ADDENDUM #3

Will County Health Department
BID PACKAGE #2 – Misc. Steel/Structural/Enclosure
November 8, 2018

**SECTION 00 91 06
BP #2 - ADDENDUM NUMBER 3**

PROJECT: **WILL COUNTY HEALTH DEPARTMENT - NEW HEALTH DEPARTMENT
BUILDING
501 ELLA AVENUE
JOLIET, ILLINOIS 60433**

SHEET NUMBER
S321

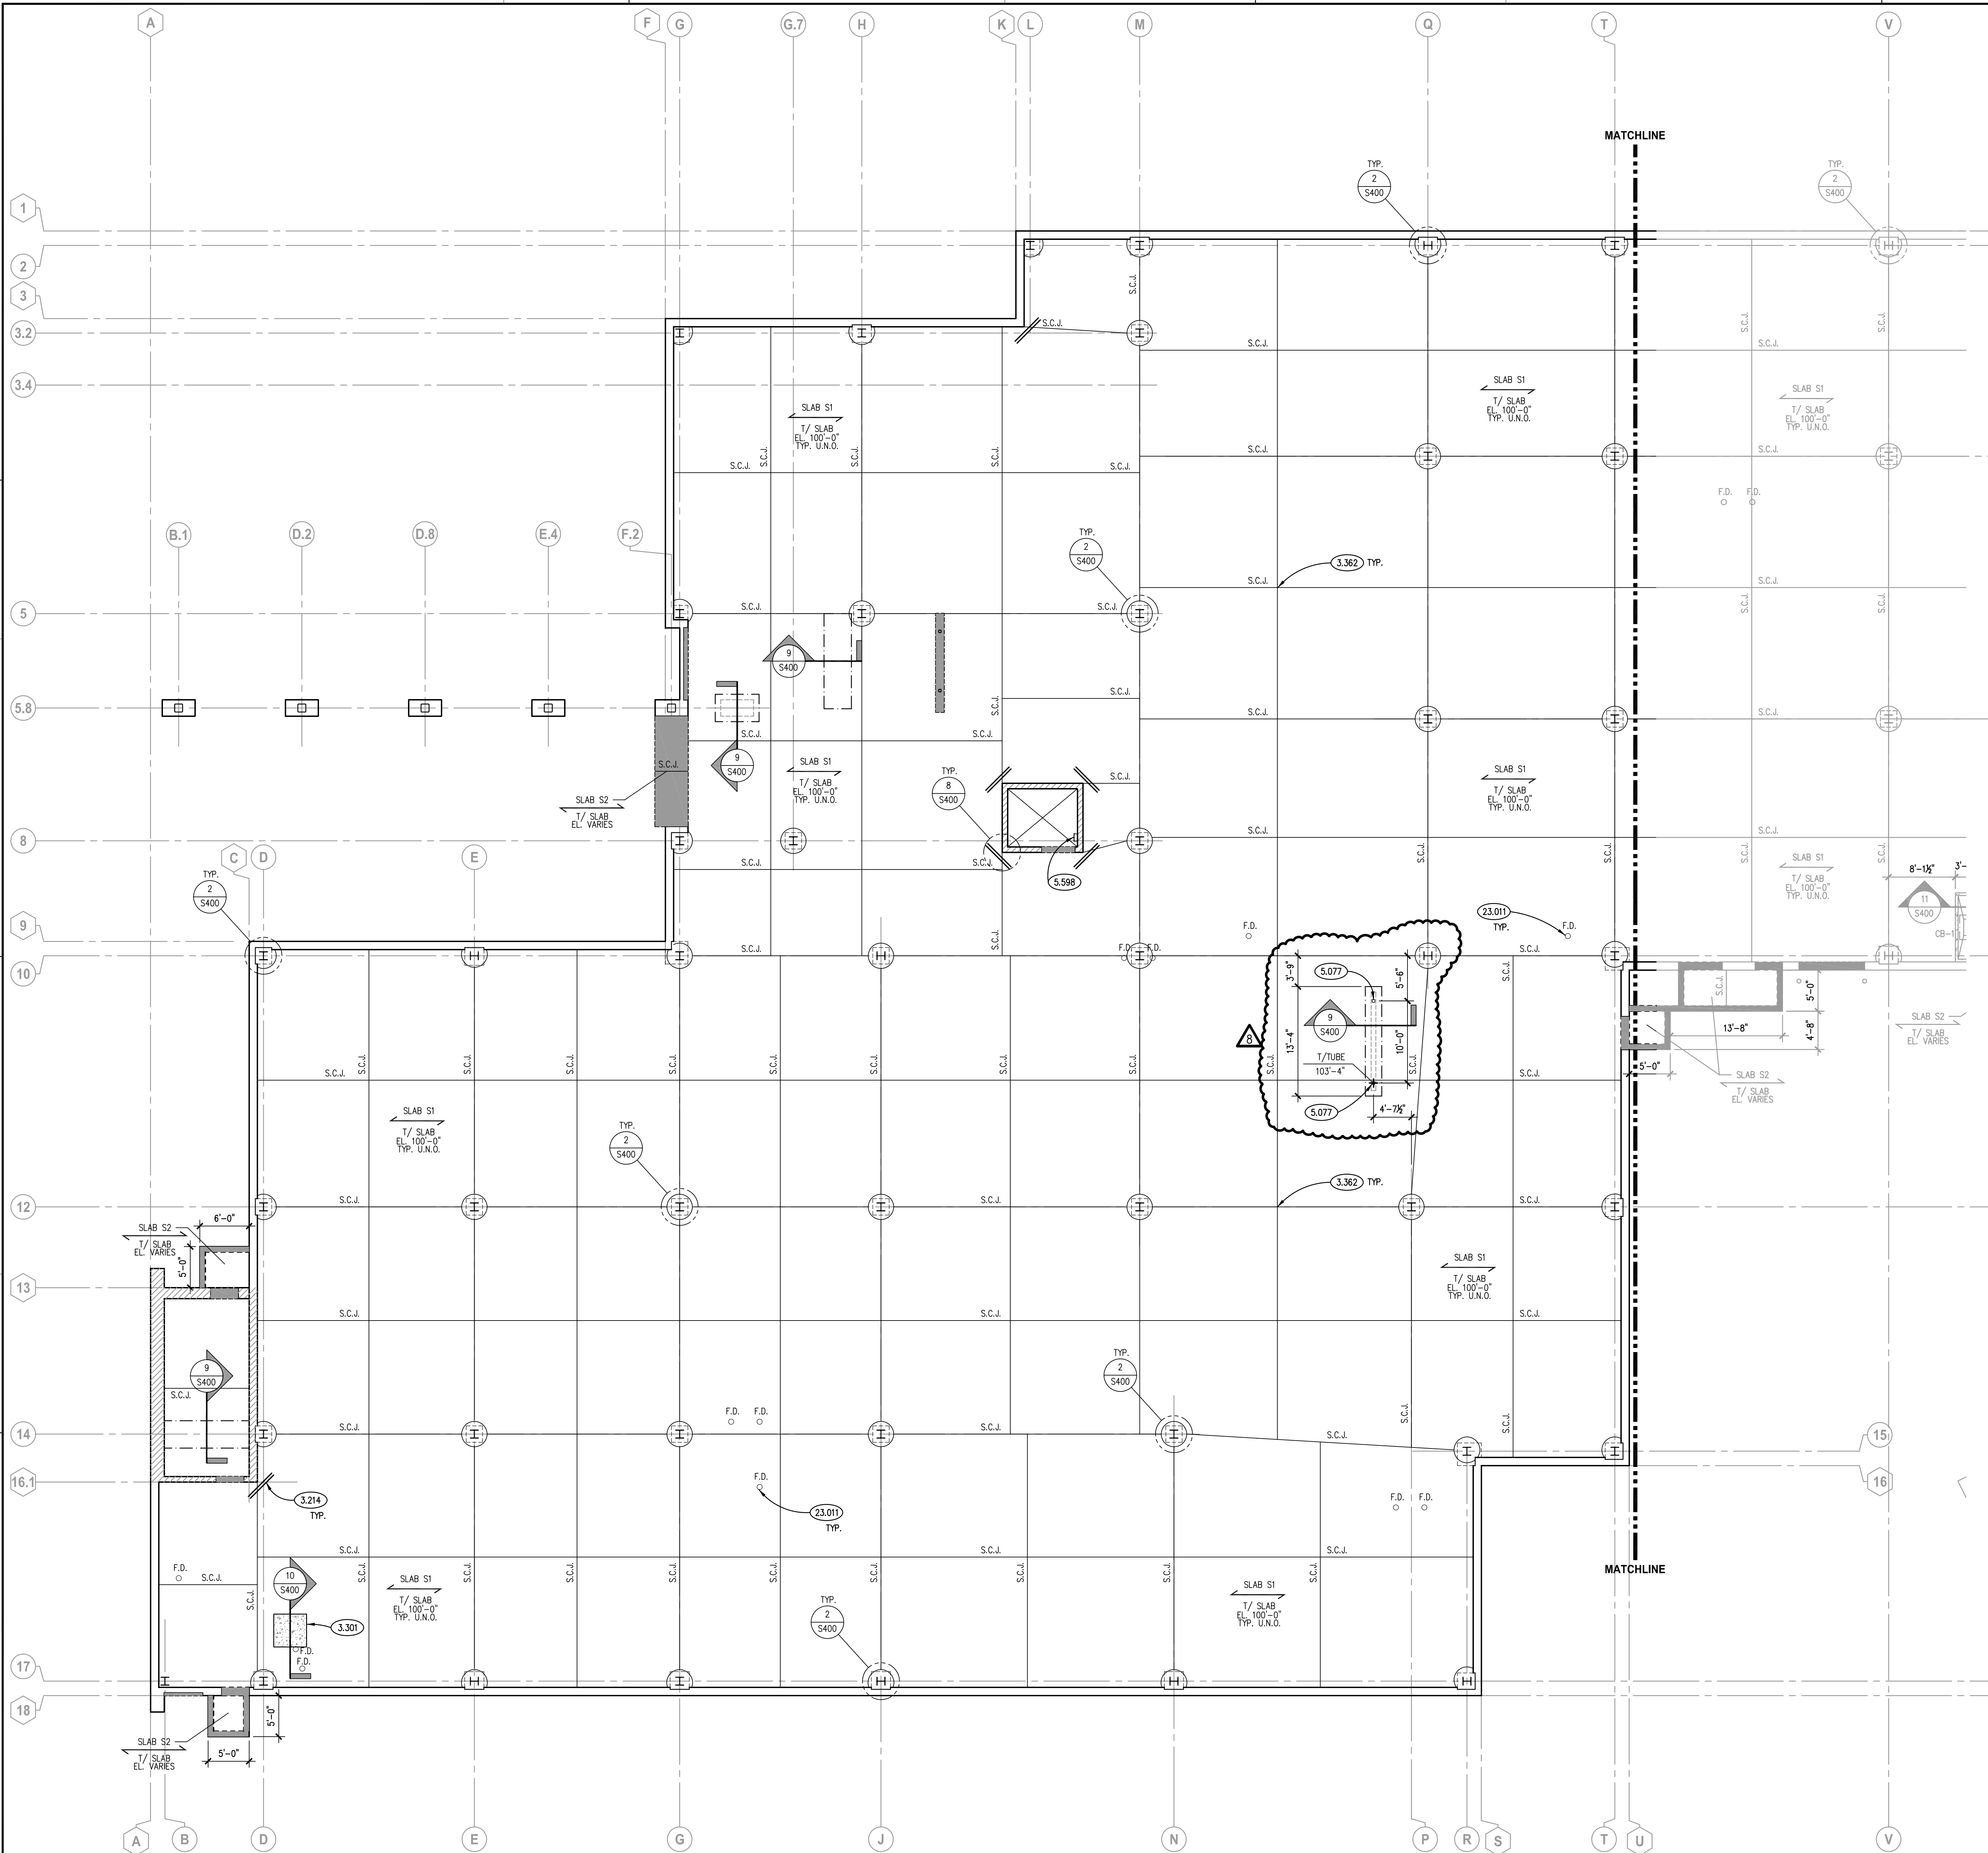
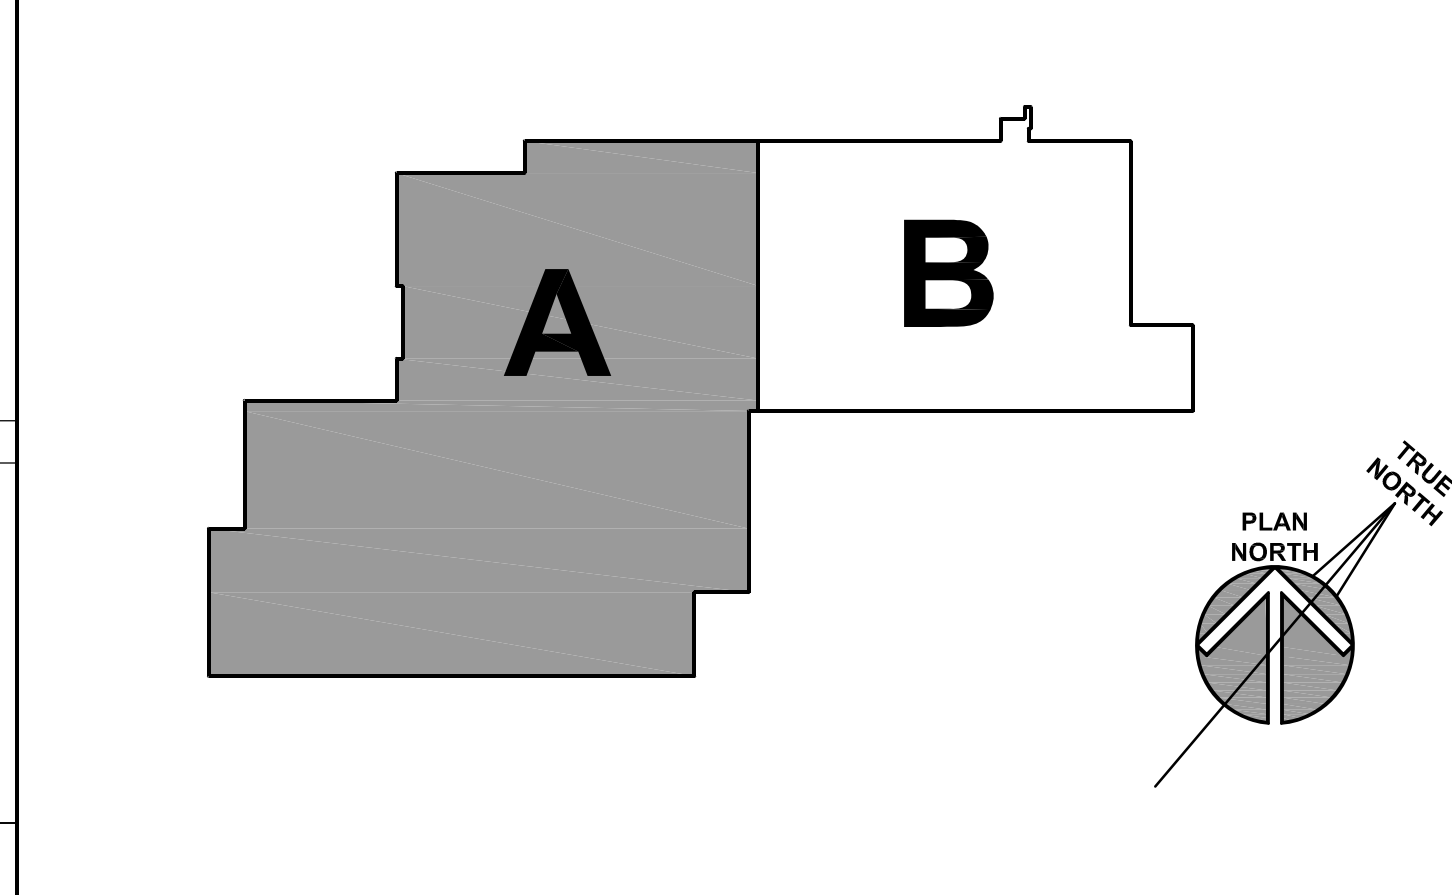
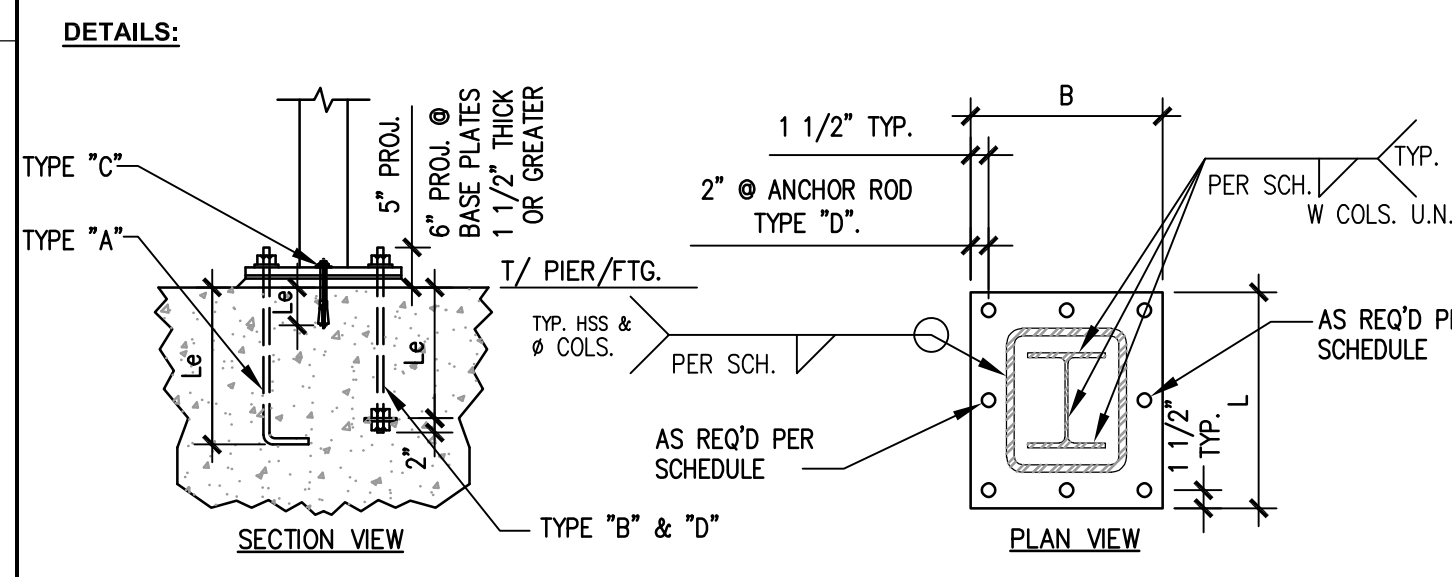
2.02 DRAWING S321 - PARTIAL SECOND FLOOR FRAMING PLAN - AREA 'A'

- A. Delete drawing in its entirety and replace with drawing number S321 (attached). Refer to revision cloud 8 for specific changes.

SHEET NUMBER
S311S

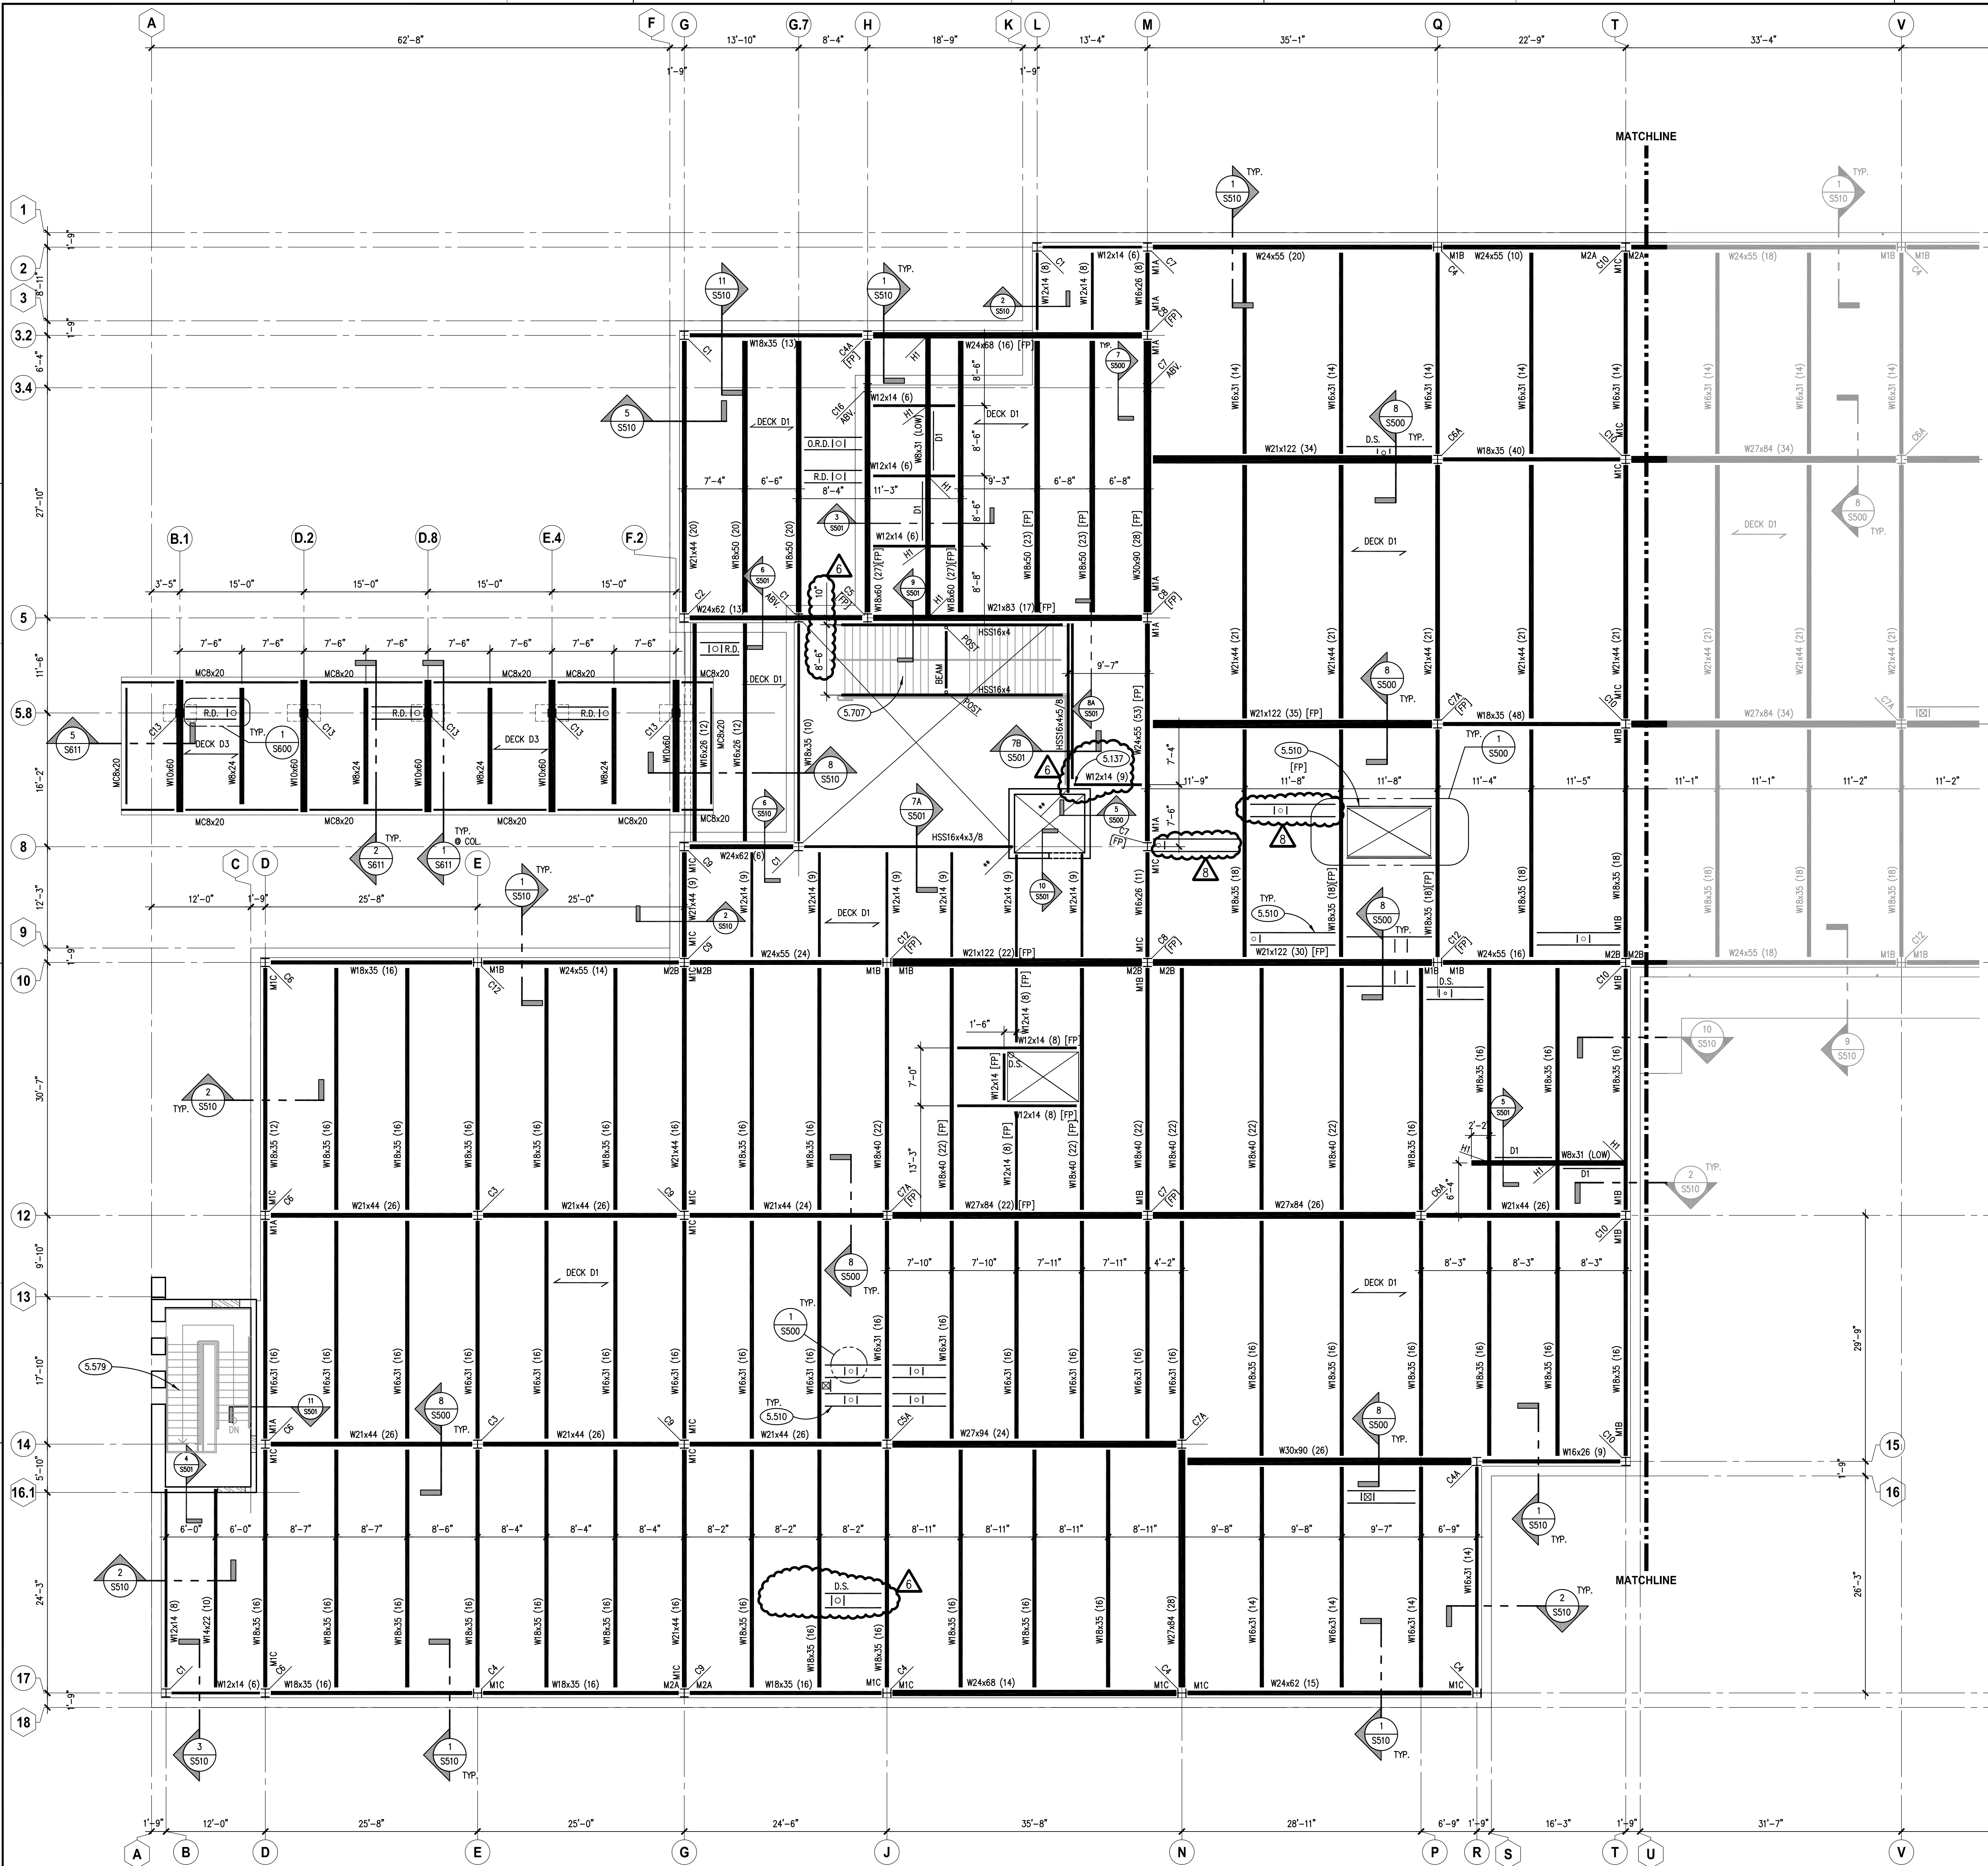
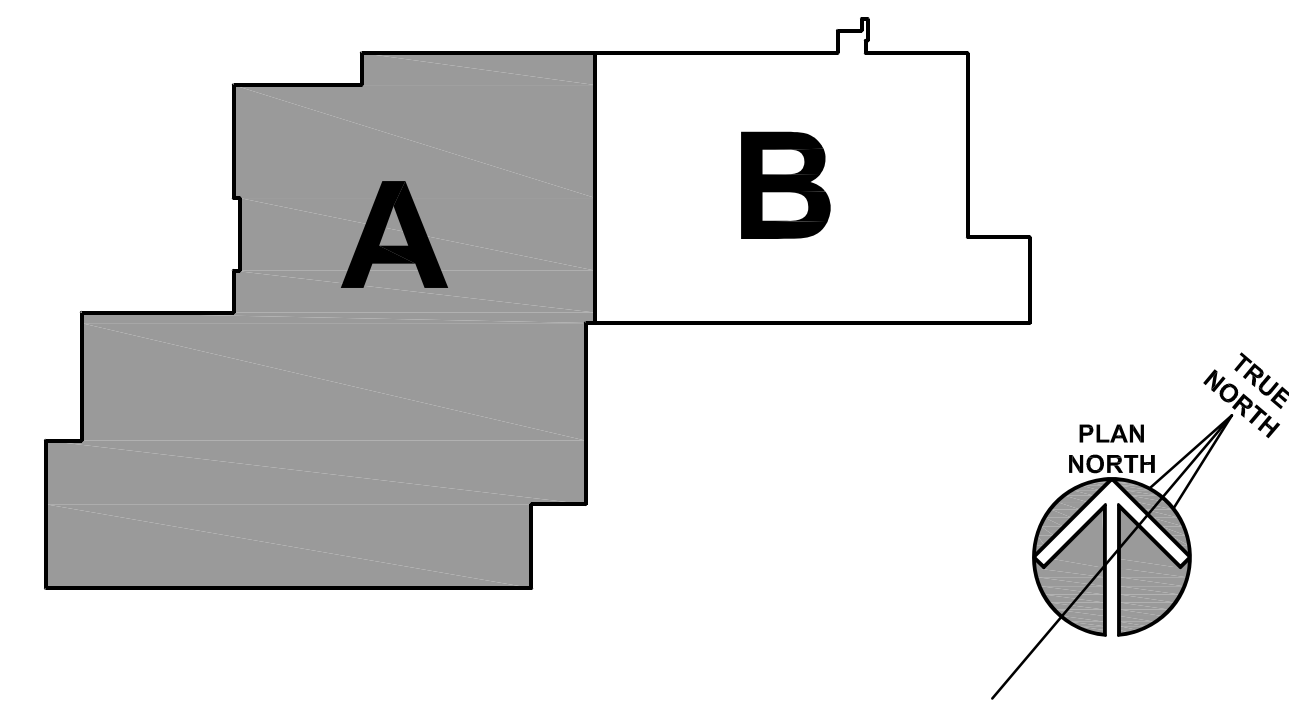
2.01 DRAWING S311S - PARTIAL SLAB ON GRADE PLAN - AREA 'A'

- A. Delete drawing in its entirety and replace with drawing number S311S (attached). Refer to revision cloud 8 for specific changes.
